World Forum for Harmonization of Vehicle Regulations

Proposal for the 02 series of amendments to UN Regulation No. 152 (AEBS for M₁ and N₁)

Submitted by the Working Party on Automated/Autonomous and Connected Vehicles*

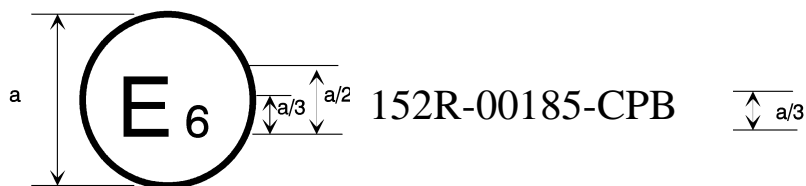
Annex 2, amend to read (addition of a letter "B" in the marking and its reference in the text):

$a = 8 \text{ mm min}$

The above approval mark affixed to a vehicle shows that the vehicle type concerned has been approved in Belgium (E 6) with regard to the Advanced Emergency Braking Systems (AEBS) pursuant to UN Regulation No. 152 (marked with C for Car to Car, P for Car to Pedestrian, B for Car to Bicycle). The first two digits of the approval number indicate that the approval was granted in accordance with the requirements of UN Regulation No. 152 in its original form."
